**Subject: Cutler Hydroelectric Project (FERC Project No. 2420)
Filing of Initial Study Report Response to Comments**

INITIAL STUDY REPORT COMMENT RESPONSE TABLE

CALIBRATED CROSS SECTION MAP

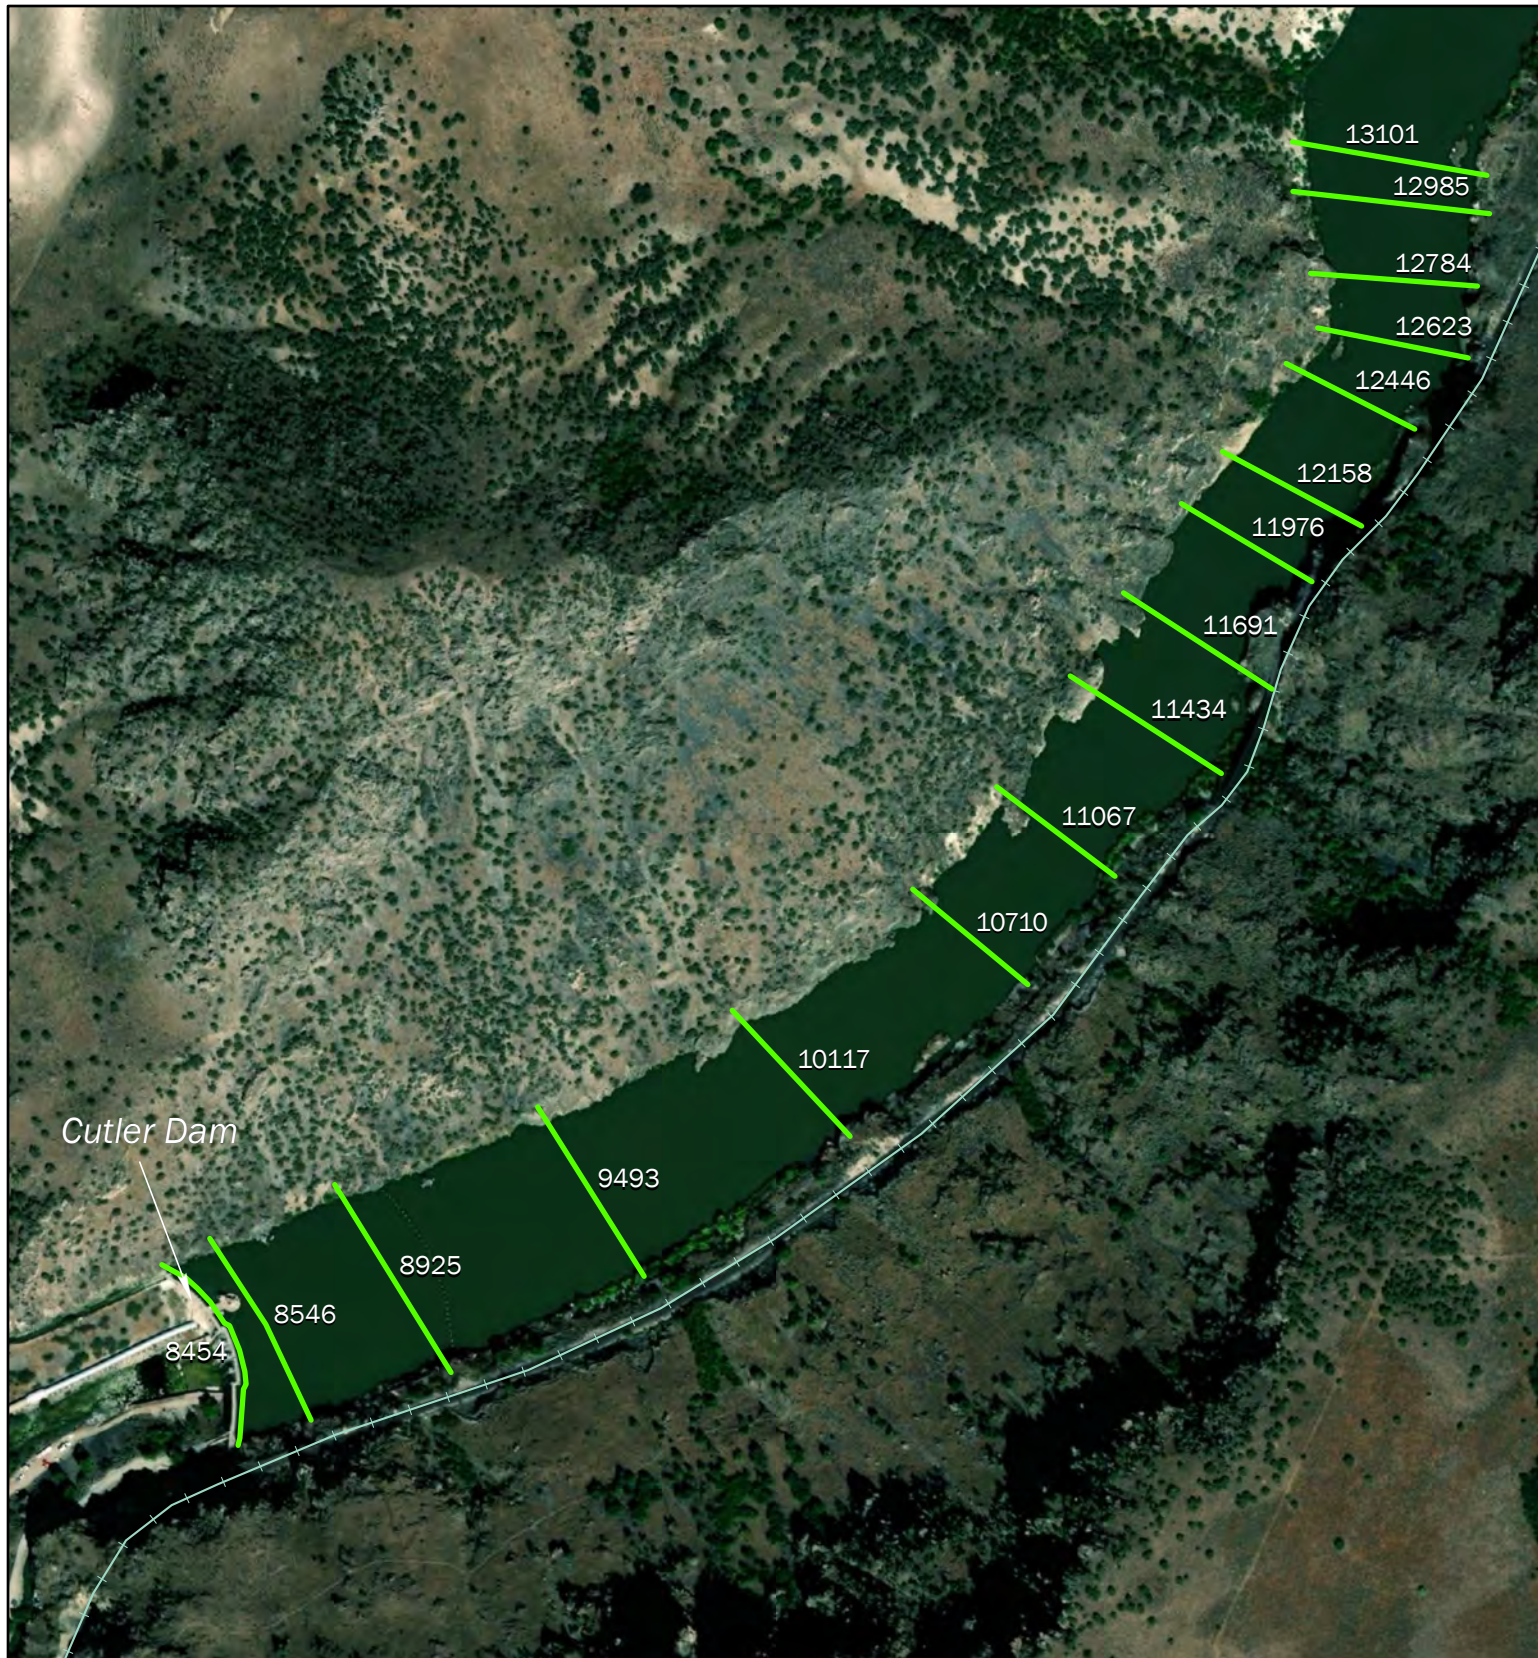
54	USFWS	5	Sediment	<p>Using the available information in the ISR, it is difficult to determine where the reservoir bed cross-sections were measured; in Appendix G, Attachment G-8, page 1 through page 8, the labels of the cross sections showing the changes in bed profiles do not correspond with the labels of the cross-sections shown in Attachment G-17, page 1 (see below). There is no way to currently determine where the greatest bed scouring and sediment mobilization will occur in the reservoir with the current information that has been provided. We request that the cross section labels be checked for accuracy, or that a map be created showing where the cross sections are located.</p>	<p>In the April 15 conference call between PacifiCorp and USFWS, the figures in Attachment G-8 of Appendix G in the ISR were discussed. The cross-sections included in Attachment G-8 were located within the Wheelon Reach of the study area, which is located between Wheelon Dam and Cutler Dam. In response to the USFWS request for an additional map, PacifiCorp shared during the call the requested additional map (Attachment 8) illustrating the location and model stationing of the calibration cross sections. This figure will be included in the USR and as noted, is also attached to this Response to Comments (Attachment 8). The cross-sections were selected for model calibration, as observed bed mobilization during the drawdown event was mostly limited to the Cutler Canyon portion of the reservoir. The 2D hydraulic model velocity results support this assumption, as substantial increases in velocities are generally limited to locations downstream of Wheelon Dam. Wheelon Dam acted as a main hydraulic control during the full drawdown event (note that Wheelon Dam would still be approximately 5 to 6 feet below the water surface during the lowest elevation of proposed operations, similar to current operations), with a substantially steeper gradient (energy grade line) downstream of Wheelon Dam than in the reservoir upstream of the dam.</p> <p>As explained in the conference call with USFWS, the cross-section locations referenced in Table 6-5 of ISR Appendix G are also shown in Appendix G, Attachment G-17, and are separate from those shown in the additional map provided for the calibration sections.</p>
